## SERVICE INFORMATION LETTER NO. SI62-043

Aircraft: DA 62.

Improved Routing of Cabin Heat Bowden Cable.

Figure 1.

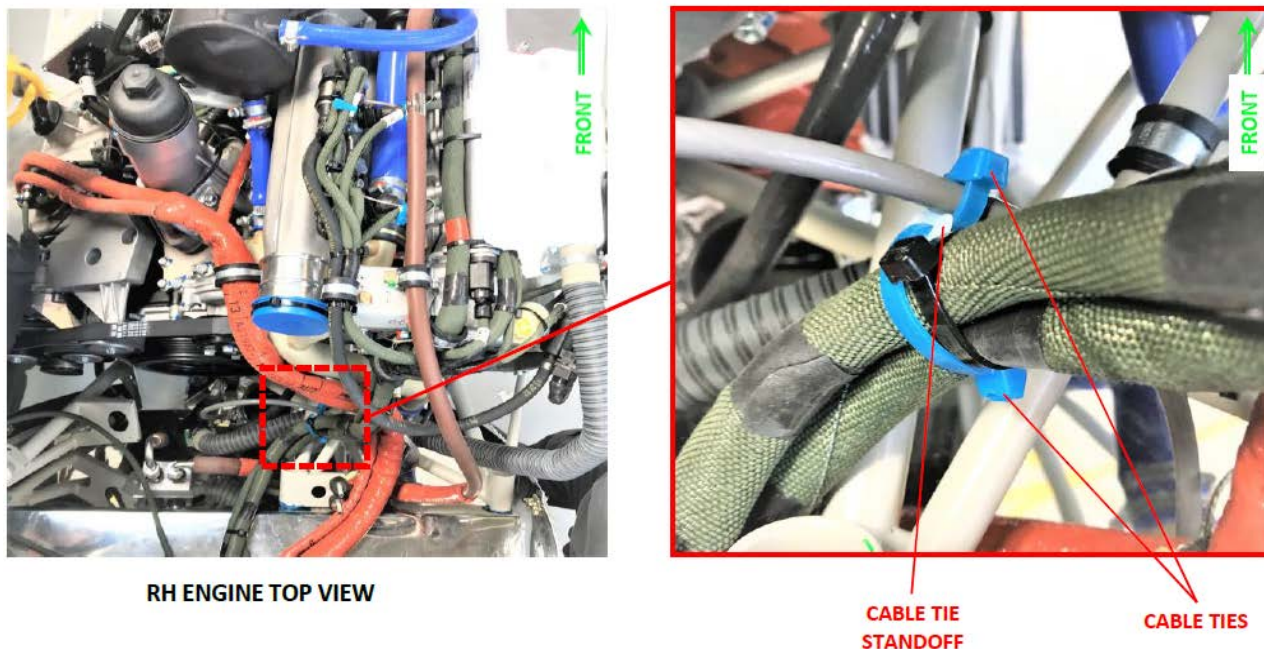
The purpose of this Service Information Letter is to inform owners and operators about the improved routing of the RH engine cabin heat bowden cable. This new routing prevents the cable from moving and touching the crank pulley, which can damage the cabin heat bowden cable.

1. Locate the cabin heat bowden cable and proceed to the next recommended step.
2. Secure the RH engine cabin heat bowden cable to the wiring harness using standoff cable tie mounts and cable ties. Refer to Figure 1.

NOTE: Make sure that the cabin heat bowden cable cannot touch engine belts or pulleys.

NOTE: Make sure that the cabin heat bowden cable is moving freely and reaching full open and closed positions.
